BAR #2023-00112
Old and Historic Alexandria District
City Council
March 16, 2024

ISSUE: Appeal of a decision of the Board of Architectural Review denying a Certificate of Appropriateness to replace windows on Early buildings in the Old and Historic District (OHAD)

LOCATION: Old and Historic Alexandria District
1021, 1023, and 1025 King Street

BAR #2023-00112
1021, 1023, and 1025 King Street

KING ST ELEVATION 1

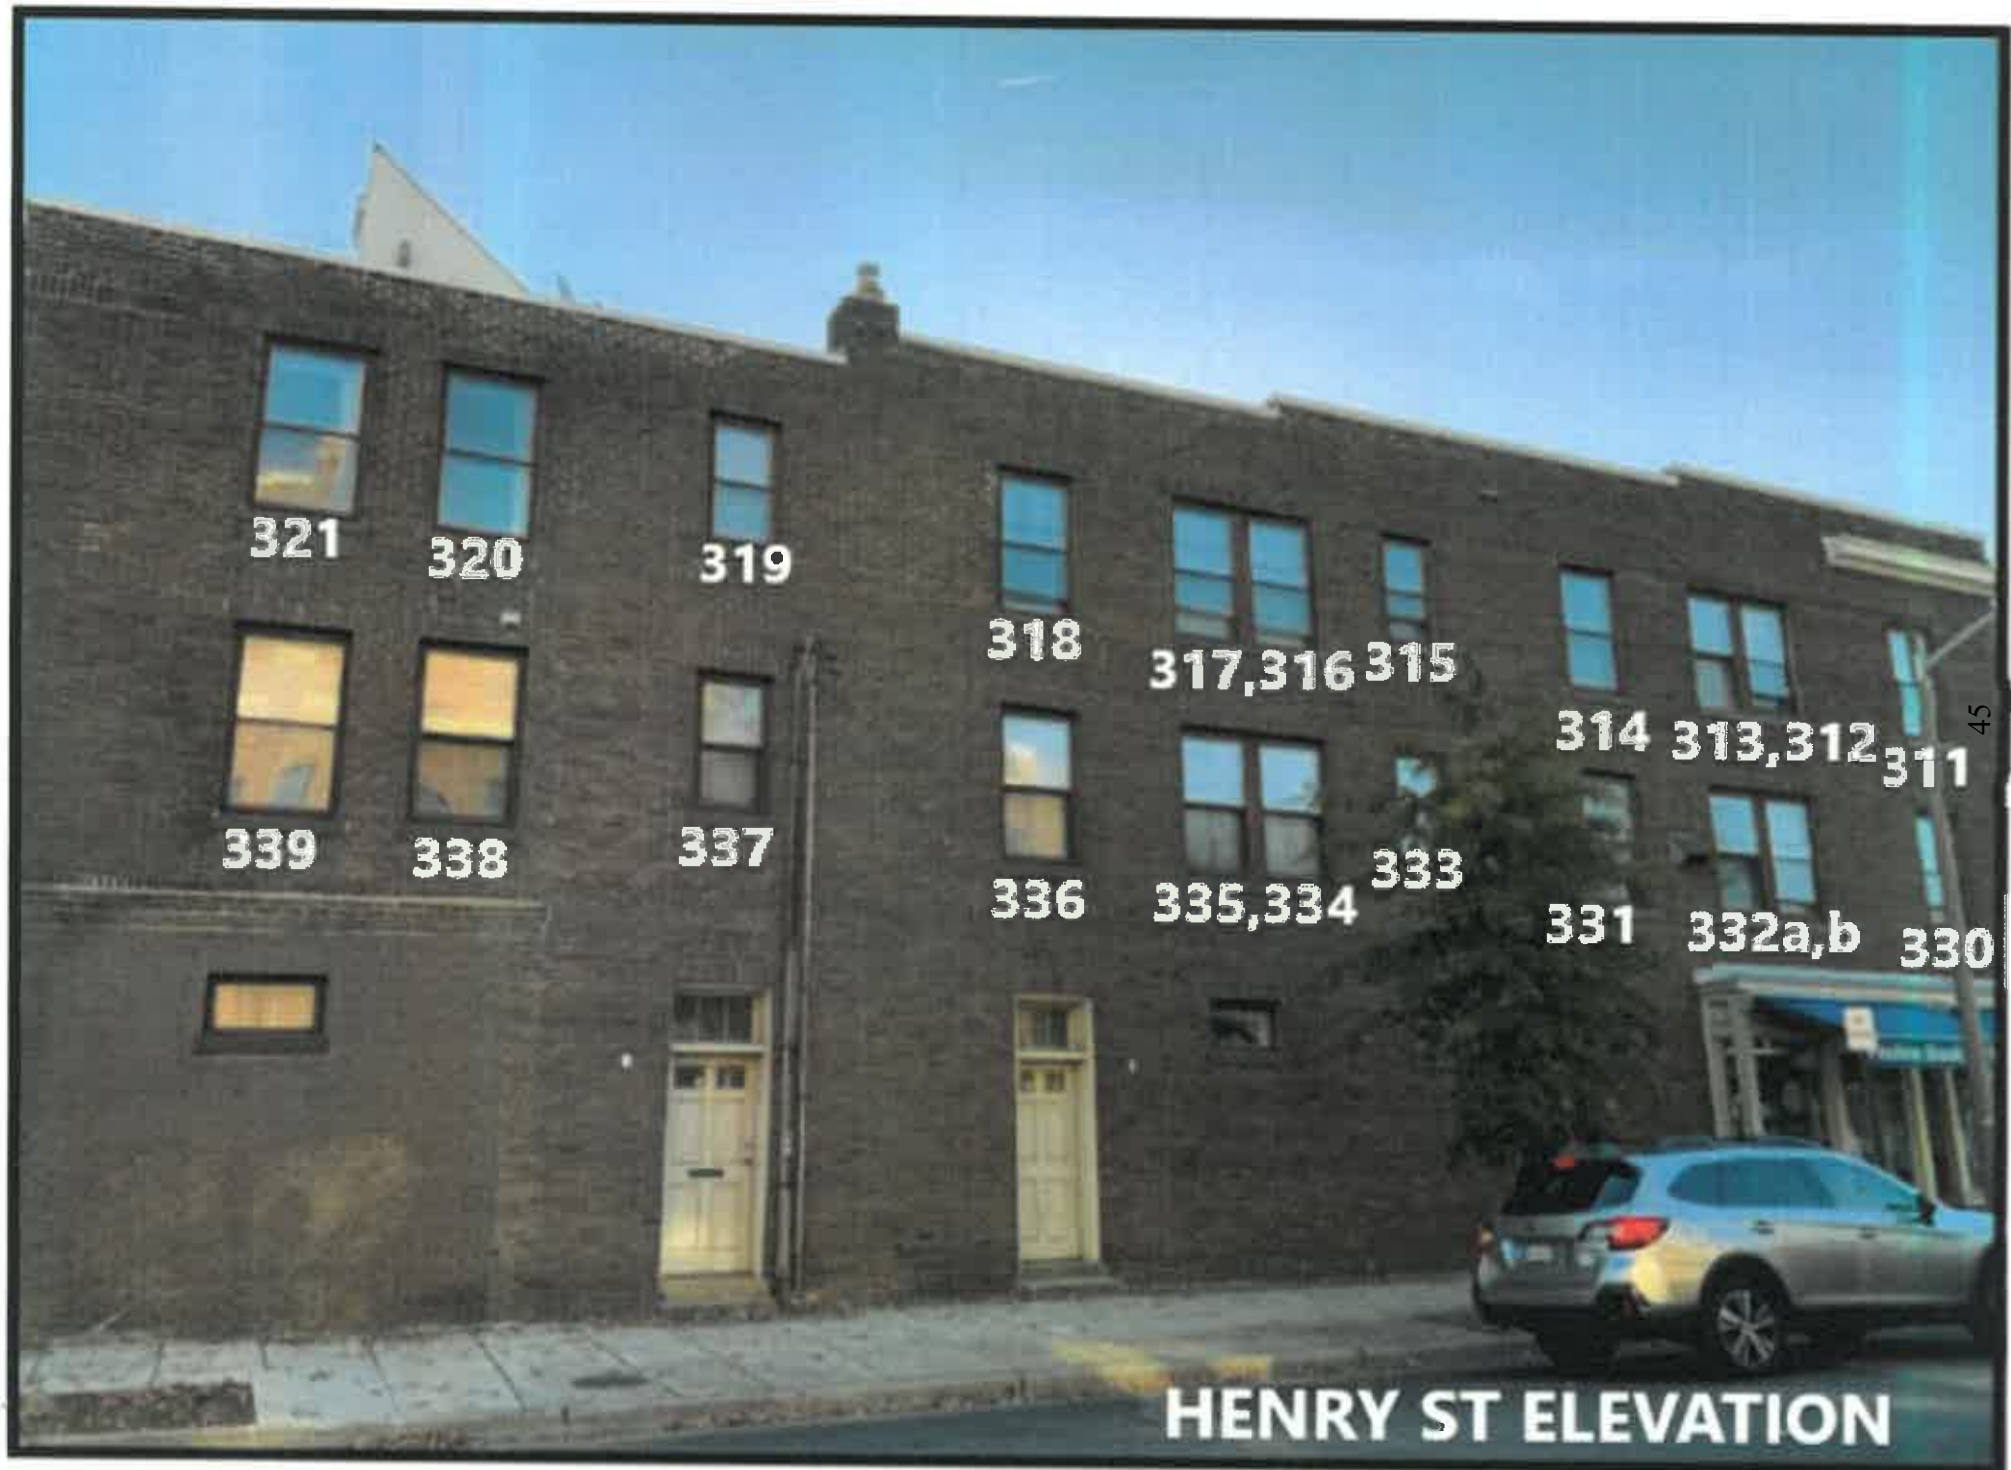
Ms. del Ninno stated that 1021 and 1023 King Street are directly adjacent to King Street and should have wood windows. The 1025 King Street building is closer to Henry Street which is more vehicular and the windows are above eye level. Would support the replacement of windows at 1025 King Street with composite windows with divisions similar to existing.

Mr. Adams stated that the King Street windows should be repaired. The arched window at the 1025 King Street elevation should be divided similar to the existing. He could support the use of composite windows on the rear of the property.

Mr. Spencer asked staff to review the existing policy regarding replacement windows in OHAD. Mr. Scott stated that 1021 and 1023 King Street should be restored or repaired where possible. He further noted that the guidelines require single pane windows on the front elevation. For 1025 King Street, he could support the use of composite windows. He suggested that the arched third floor window retain the existing configuration and include a wood frame. He could support the proposal because the application had been changed to a sash kit rather than an insert type of installation.
